MCPB  
Item No.  
Date: 11.04.21

## 7070 Arlington Road, Sketch Plan No. 320210100 and Preliminary Plan Amendment No. 11998051A

Completed: 10.25.21

*Figure 5 - Massing Diagram (looking southeast)*

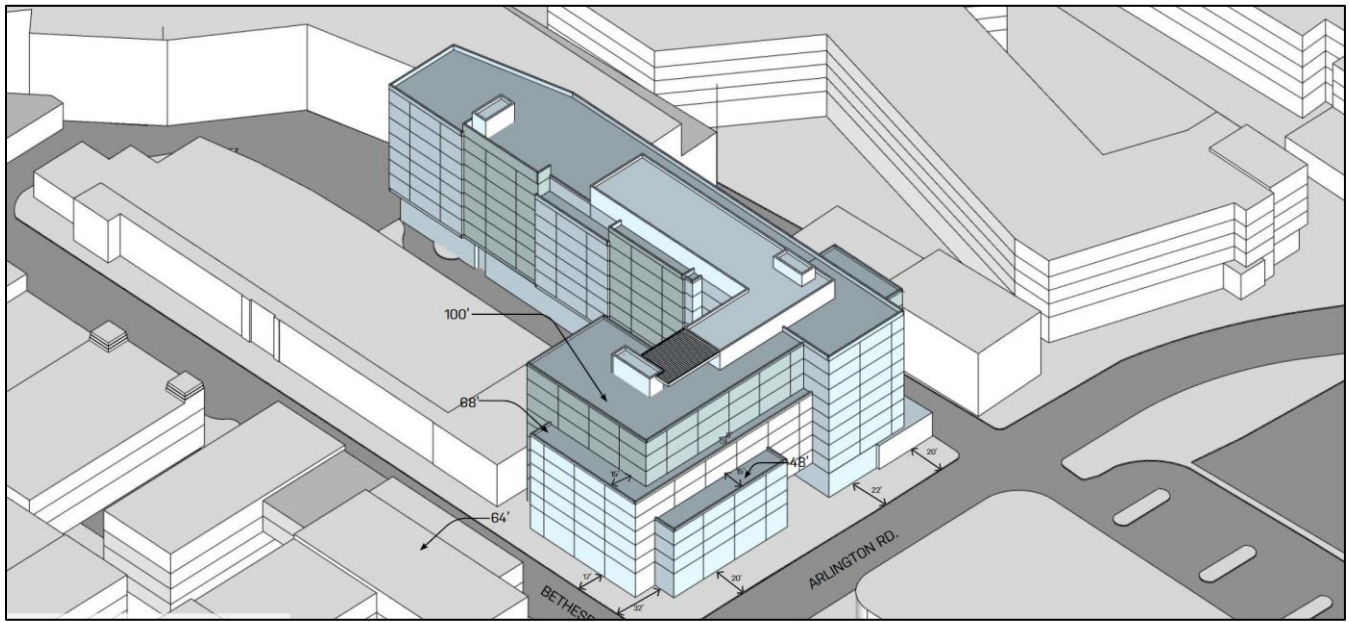
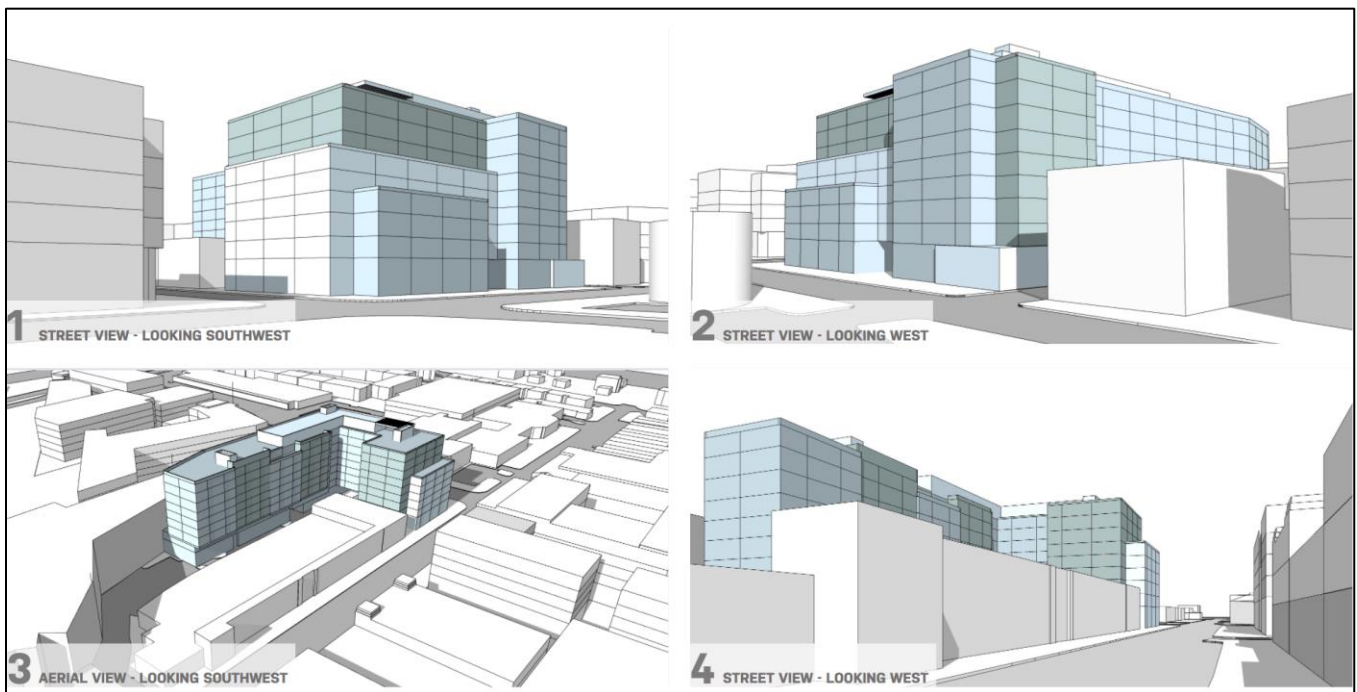
Panel (DAP) was pleased to see the site redeveloped as it is an appropriate location for additional density. The DAP expressed that the Design Guidelines surfaced well in this Project and noted the careful attention to maximizing pedestrian views from Bethesda Lane and Bethesda Avenue and the enhancing the space at the Arlington Road access point at time of Site Plan. The DAP discussed scheme preferences, material and articulation, and the proposed height and setbacks. The DAP recommended that the Applicant:

- Provide additional pedestrian views from Bethesda Lane and Bethesda Avenue approximately 50 feet west of Arlington Road looking east to study if the current setback at the corner of Bethesda Avenue is sufficient.
- Enhance the space at the Arlington Road access point to be more plaza like.
- Provide a rendered landscape plan.

At the time of Site Plan submission, the Applicant must explore methods to provide additional pedestrian views, enhance the space at the Arlington Road access point to be more plaza like and provide a rendered landscape plan, consistent with the DAP's February 24, 2021 meeting minutes.
